Re: NSTAR Electric Company, D.T.E. 06-40

Responses to Information Requests

Information Request DTE-2-9

Existing electric system in Cambridge:

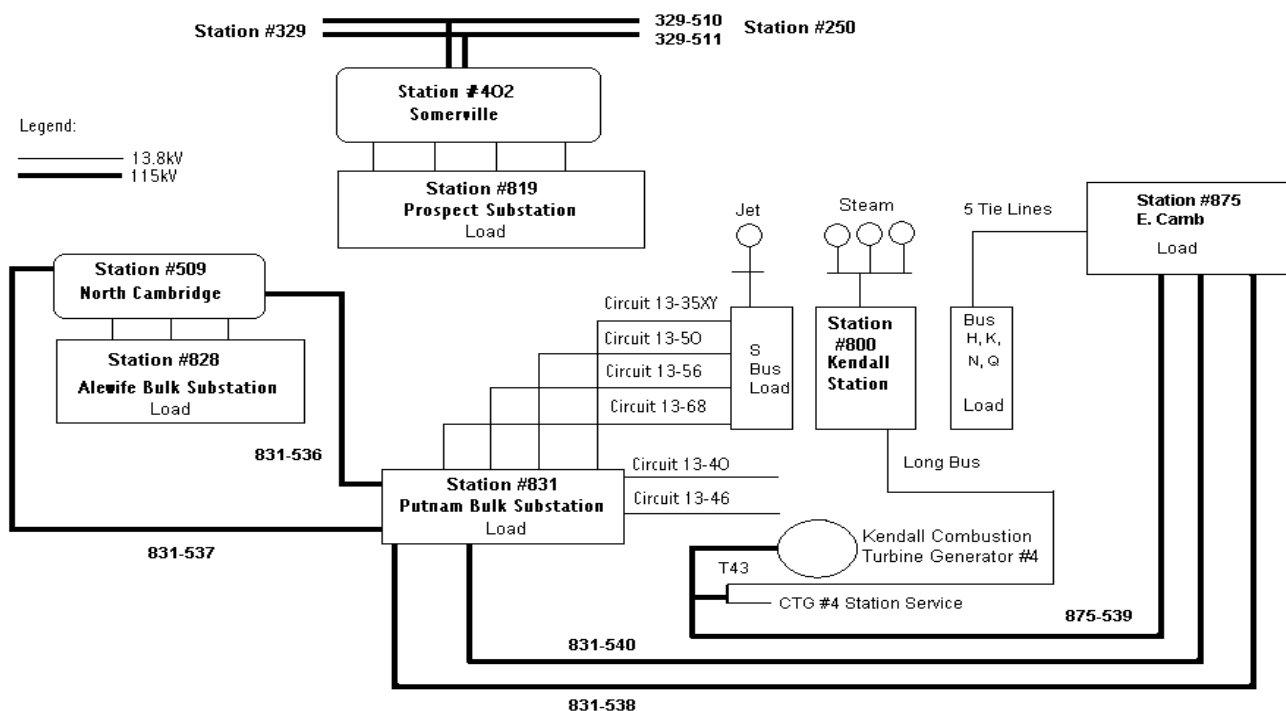
Refer to Exh. NSTAR-CLV-1, at 21. Please provide a detailed list of all the structural changes that were made that resulted in Cambridge's 13.8 kV facilities changing from an integrated transmission network to a distribution system that provides power to local load. Include the dates that any such structural changes were completed.

Please refer to all changes listed in the responses to Information Request DTE 2-8 and Information Request DTE-2-11. Cambridge has built a substation in the East Cambridge area and is presently completing the second 115 kV cable to that station. Once the station is in service and changes in the operational connection of the 13.8 kV intra-tie cables¹ are operational, the system will be configured as a radial distribution system rather than as transmission. The installation of the second 115 kV line is scheduled to be completed by the last quarter of 2006. At that time, Cambridge will start the process of moving circuits to the new station, thereby allowing steam generation facilities at Kendall to be connected to the 115 kV system and permitting the dissolution of the intra-ties as ties and converting them to radial circuits by mid-2007. Please refer below for diagrams of the existing configuration and the planned configuration.
